WATER PERMIT NO. 2010-1

**SOUTH DAKOTA
WATER PERMIT NO. 2010-1**

JERDE DAM
POND

Plan & Specification Review

PLAN VIEW AND DESIGN DATA

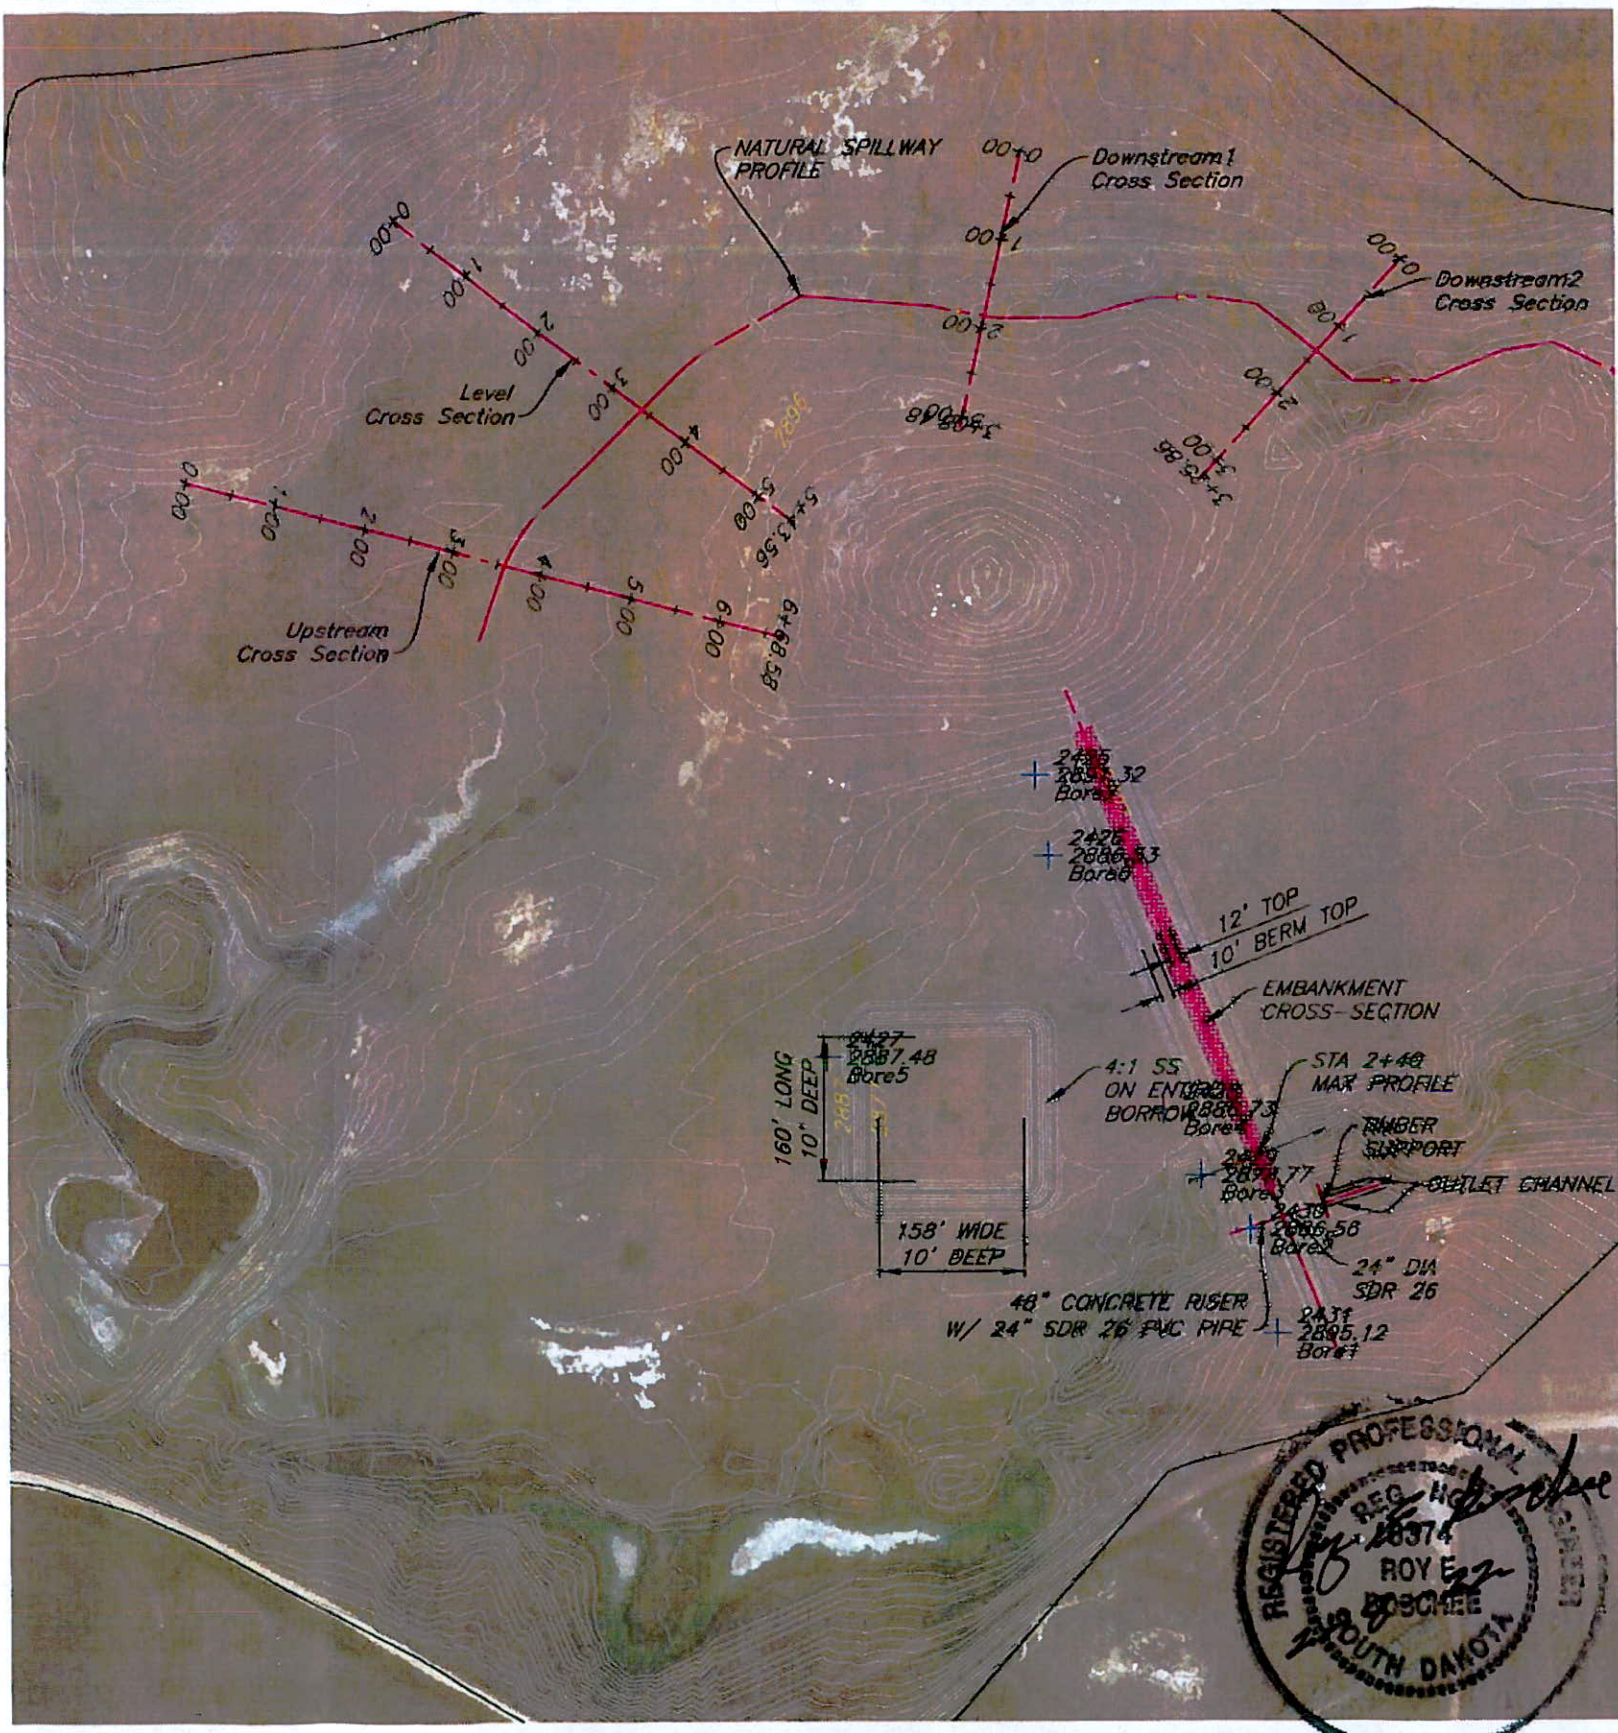
(1) Top map Yes
on sheet 5-1

Height __19ft (from plan sheet 2) ____

Design peak flow in plans _50yr 24 hr (sheet 2)- peak runoff 832 cfs__

JERDE DAM
POND
MAX CROSS SECTION AND EMBANKMENT PROFILE
Perkins County, South Dakota
33-16N.17W-10E

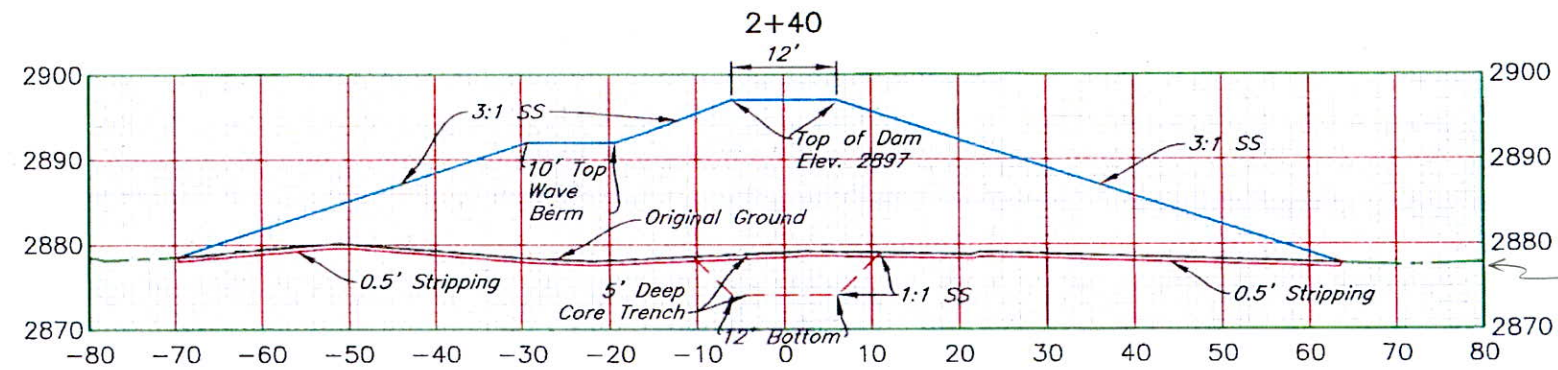
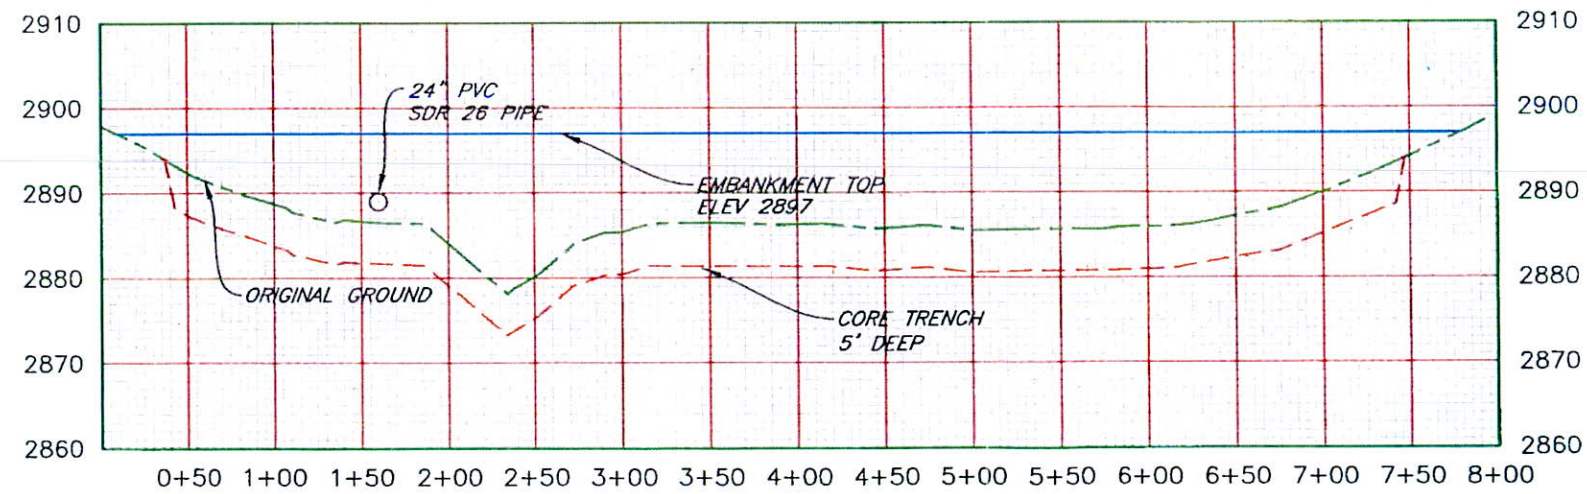
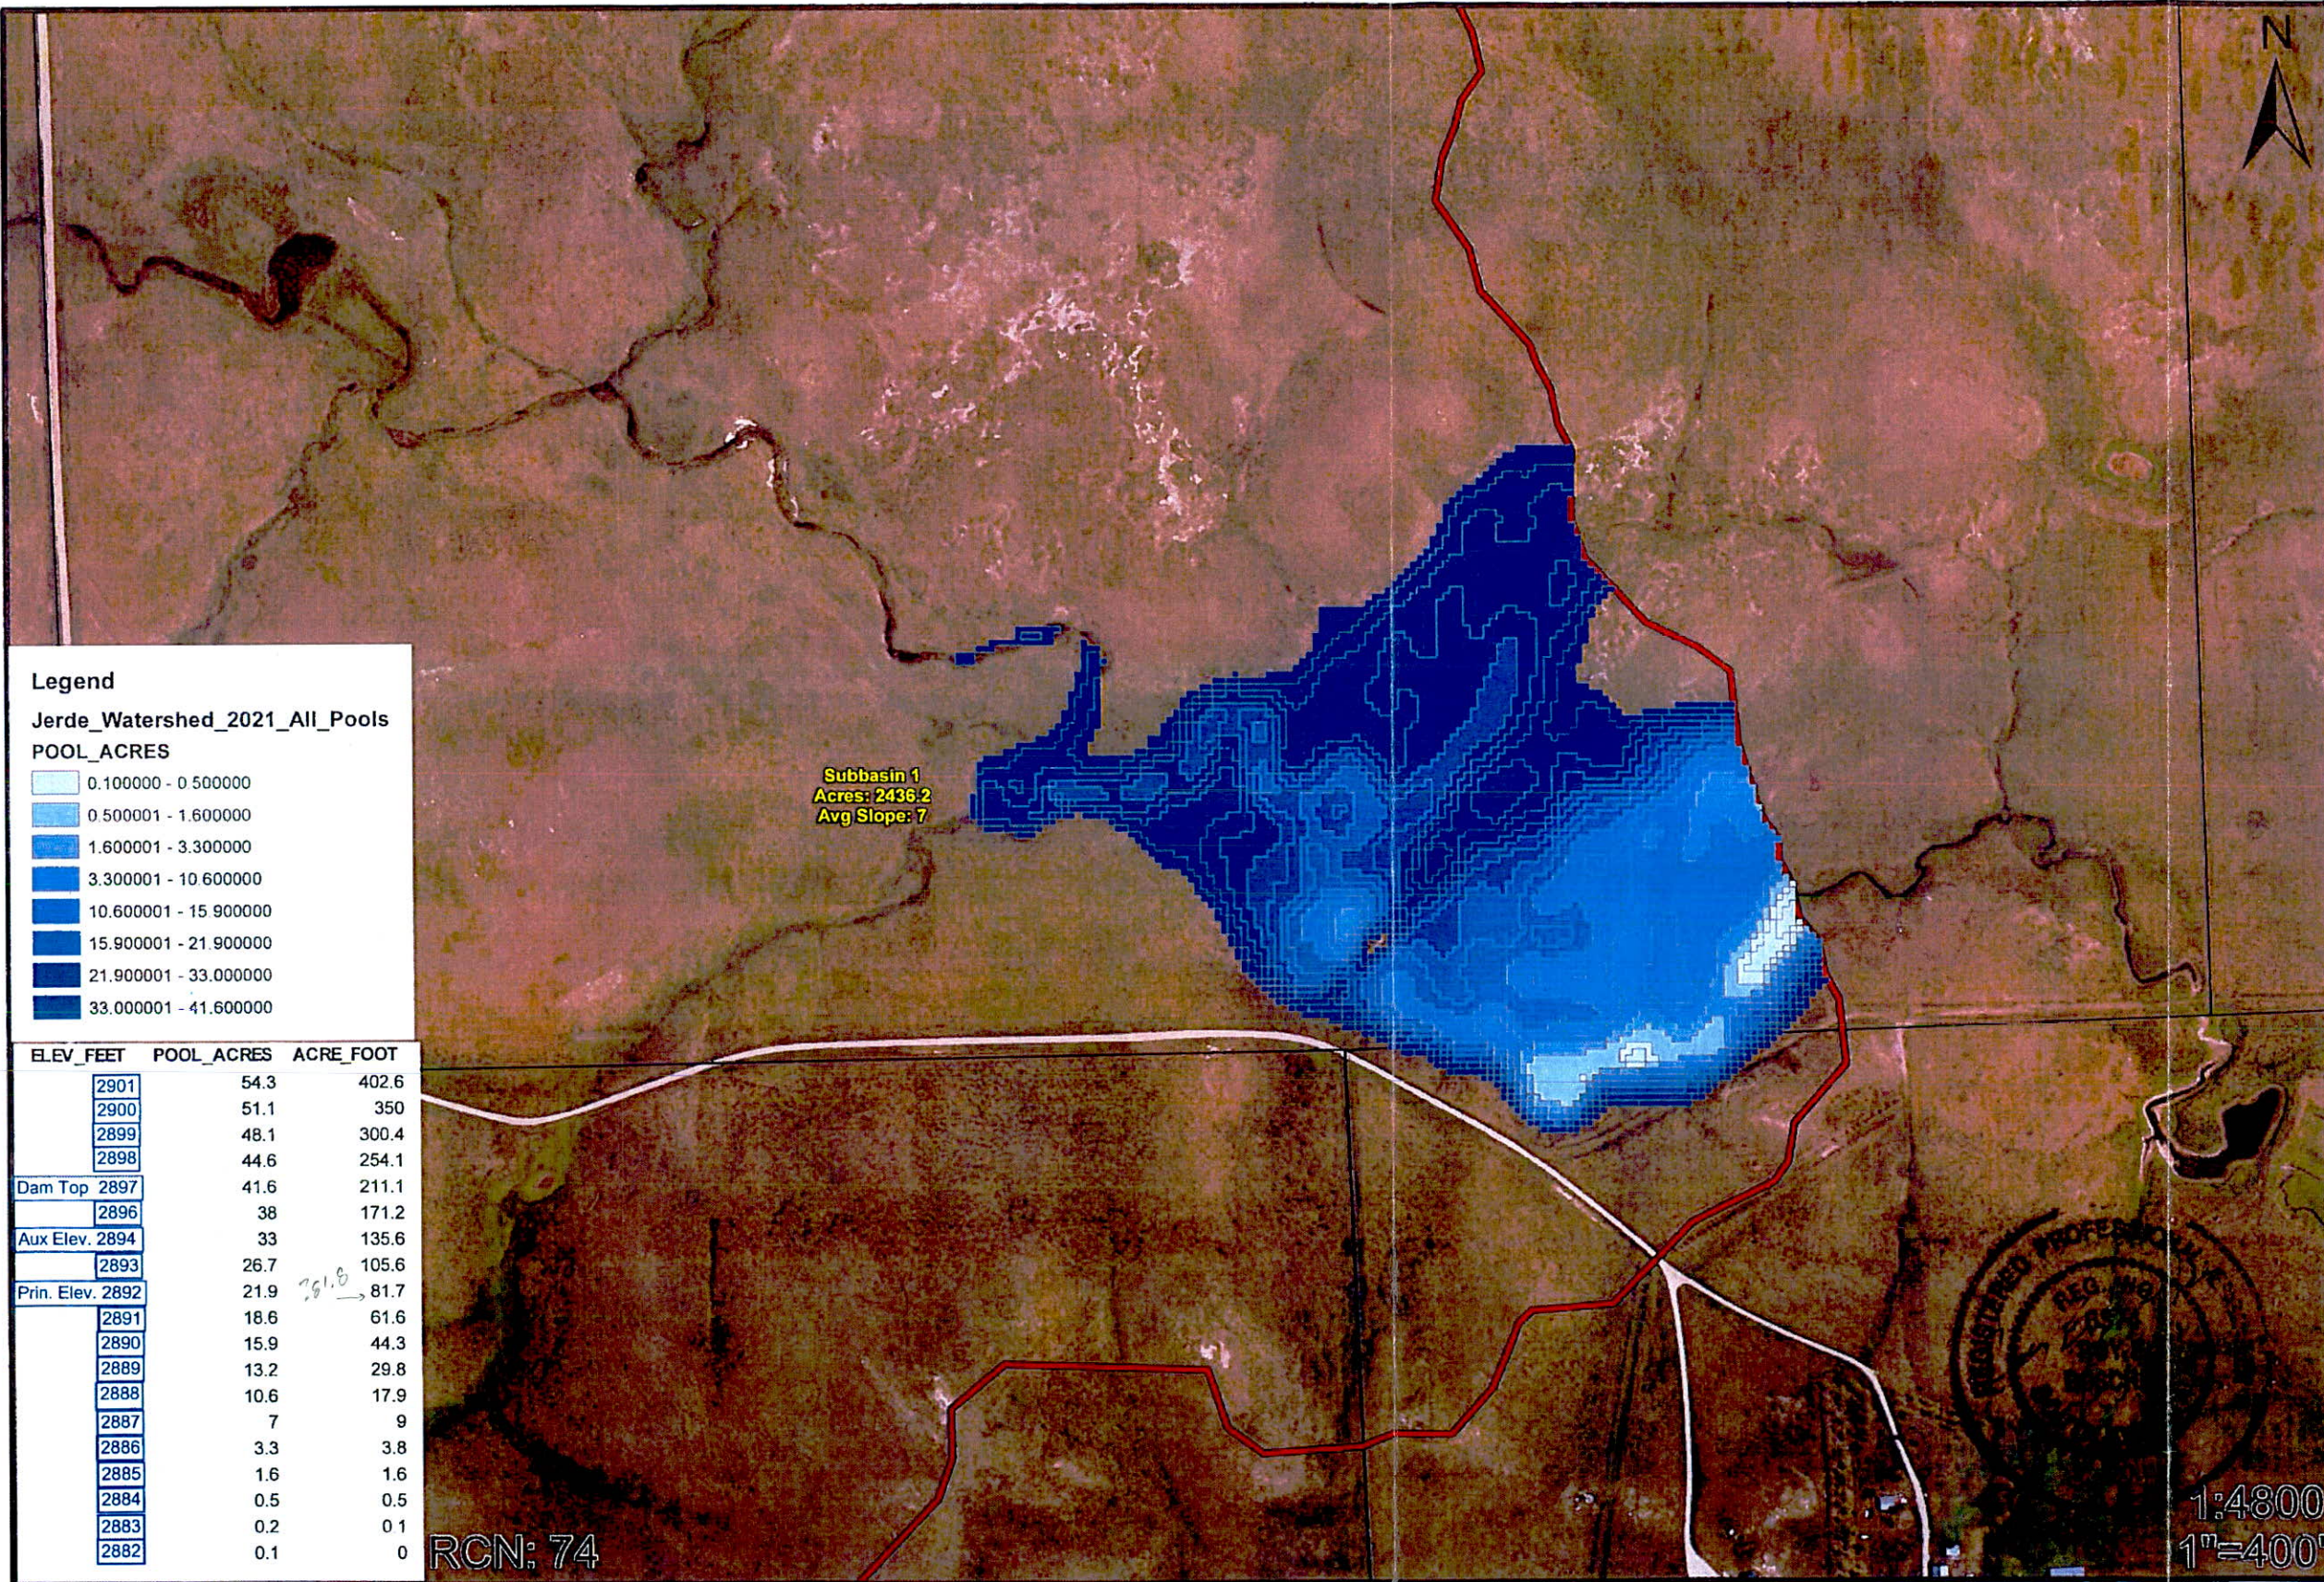
Downstream embankment toe elevation 2897 - 19 = 2878 *← from dam x-sec sheet*

(3) Dam max X-section Yes
on sheet 3
